Email: info@ottershawforum.com Website: www.ottershawforum.com

SCC 2021/0185 - A320 Ottershaw Roundabout (Jct 10 of SCC HIF Scheme) – ONF Representations

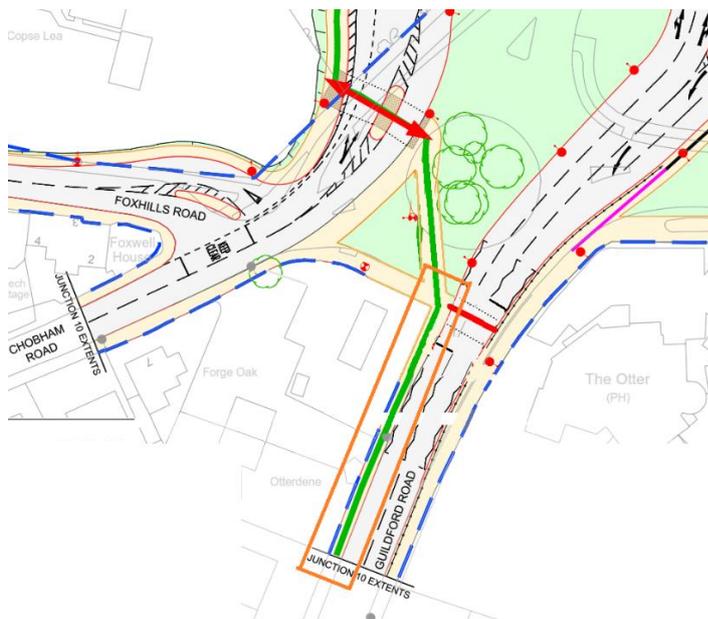
Impacts on Ottershaw outside of the scheme. In its current form the roundabout will clearly remain a bottleneck and traffic from Woking and Addlestone will increasingly seek to cut through Brox and Slade Roads to access the A320 Woking or A319 to Addlestone/New Haw. A part mitigation would be some form of speed control/traffic calming along these

roads together with addressing on street parking in the village. This is critical to ensure safety and better manage congestion. The scheme should not progress until a solution is in place because the impacts will be felt in the near term immediately the works commence.

Guildford Rd South NCR223 Bottleneck. The southern end of the HIF scheme on Guildford Rd is currently a major bottleneck on the National Cycle Route 223 (orange box on diagram). It consists of a shared foot & cycle path so narrow that it does not even meet the standards for a footpath. The proposed scheme fails to address this key issue and therefore neither meets Cycle Infrastructure Design core principles (safe & comfortable) nor National Cycle Network design principles (to be wide enough to accommodate all users).

Should this remain, southbound NCN cyclists will be compelled to cross at this point and use the roadway thus further impacting traffic flow and compromising cyclist safety.

CONDITION – A scheme for addressing, mitigating and resolving the wider impacts on speed control, traffic calming, and on street parking on Brox and Slade Roads be Determined and agreed before proceeding with works.

CONDITION- Redesign and incorporate a standards compliant, widened combined foot & cycle path on Guildford Road between the Trident Garage and the southern boundary of the scheme, before commencement of the scheme.

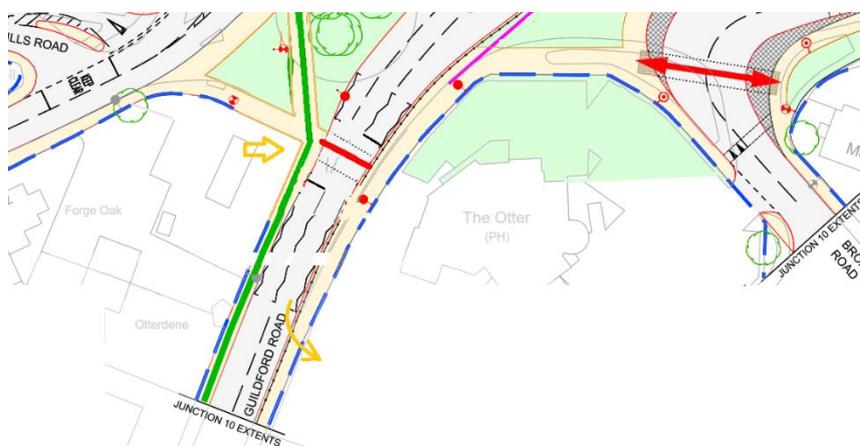
SuDS Provision. Whilst it is appreciated that SuDS provision is important to the scheme its location and capacity must be carefully considered, noting that there has been no evidence of flooding/inundation here for more than 40 years.

- Are 2 areas required or can this be reduced to one. Would the promontory be a better place given its limited role in the scheme?
- Does the inclusion of SuDS on the roundabout result in the removal of the mature trees. Is it required? If a second SuDS is required, could this be relocated, possibly onto the peninsula?
- Can the proposed area of SuDS to the NE of the roundabout be reduced or excluded to allow for improved landscaping/provision of second car park?
- Details of the surface water collection and discharge to the new proposed carriageways and landscape areas to be prepared and consulted upon.

CONDITION. A detailed scheme for the disposal and temporary retention of surface water drainage (SUDS) shall be prepared minimising the land area utilisation on the NE of the roundabout, in consultation with RBC and the Local Community (ONF).
